***Reconfiguration of Orangeville TS
Notification of Conditional Approval of Connection Proposal
CAA ID Number: 2010-EX500***

Final Report - Expedited System Impact Assessment – revised October 11, 2011
Hydro One Networks

Figure 1 – Existing Configuration of Orangeville TS

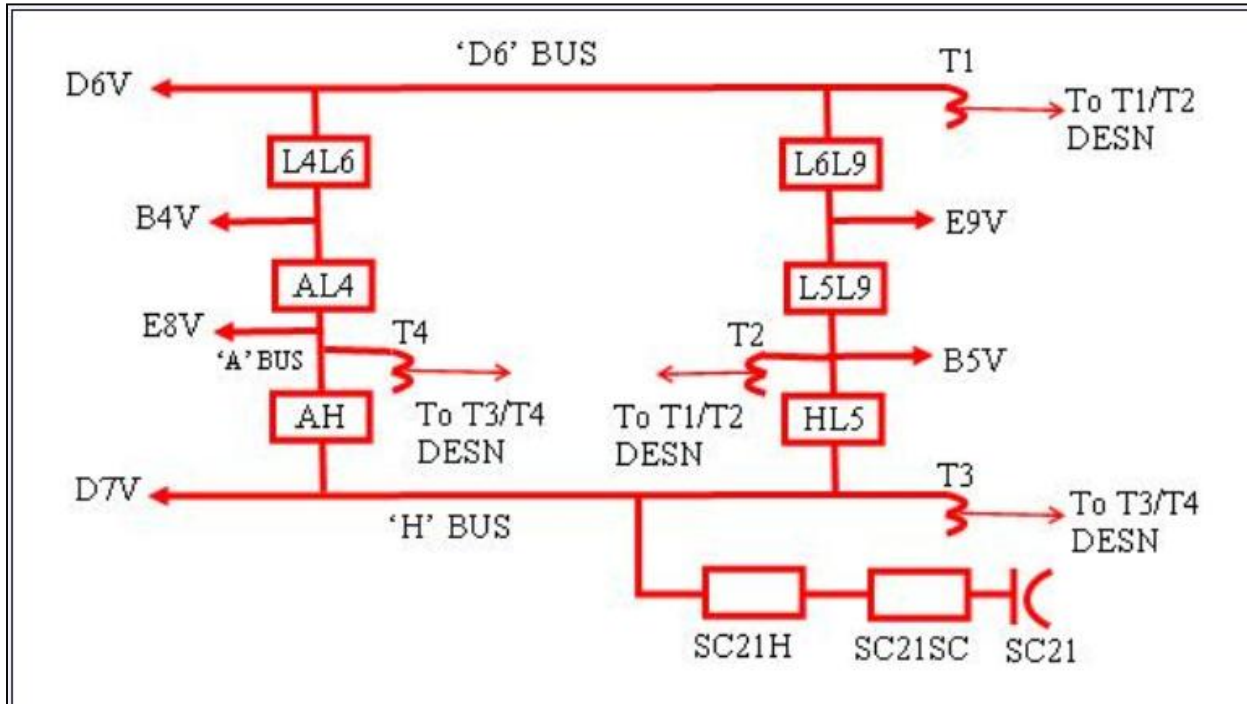
Under the existing configuration at Orangeville TS a breaker failure condition of HL5 results in the loss of the 230 kV circuits D7V and B5V as well as the shunt capacitor SC21. This is particularly onerous for the load supplied from the remaining DxV circuit since the loss of the capacitor bank occurs when increased reactive losses are being imposed on the system as a result of the simultaneous loss of one of the DxV circuits and one of the infeed circuits into Orangeville TS (B5V).

Figure 2 – Proposed Configuration of Orangeville TS

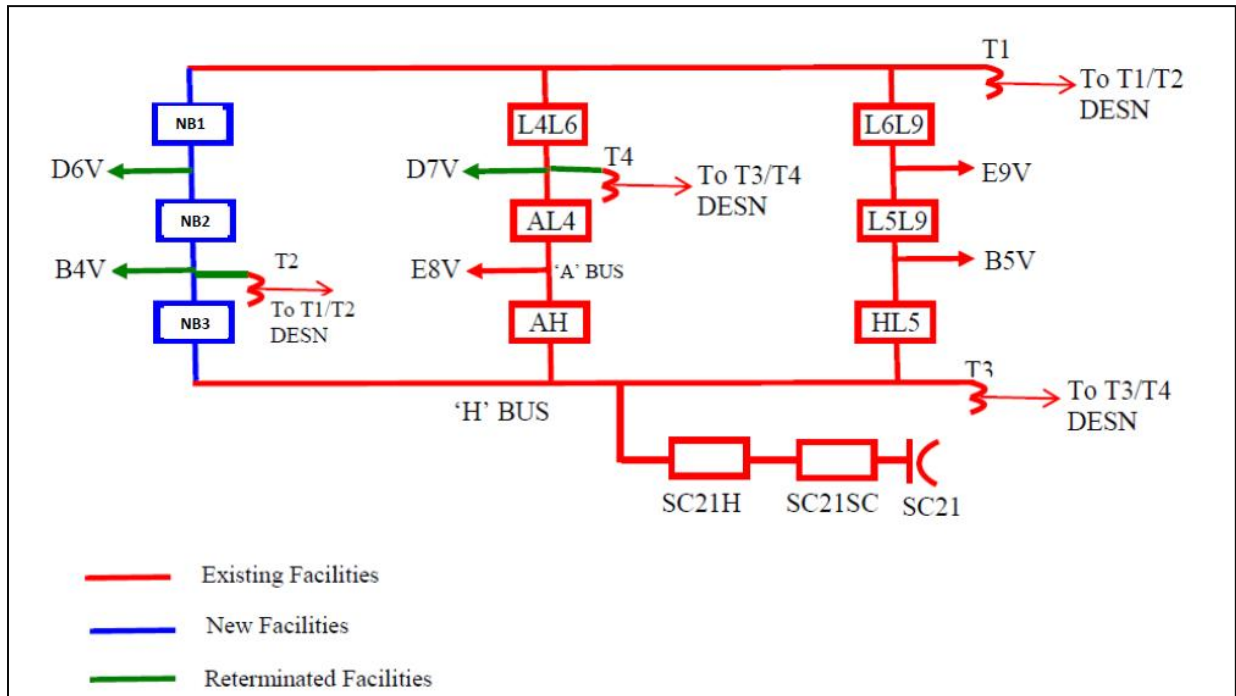
The proposed re-configuration of Orangeville TS is shown in figure 2 below. The three new breakers have been identified as NB1, NB2 and NB3. The actual nomenclature will be provided later for all breakers in the station to reflect the new station configuration.

With this arrangement, a breaker failure of HL5 will result in the loss of B5V and SC21, while a breaker failure of NB3 will result in the loss of the 230 kV circuit B4V and SC21. This proposed arrangement is preferable to the alternative of losing one of the load-supply circuits (DxV) together with an infeed circuit (BxV) and the shunt capacitor.
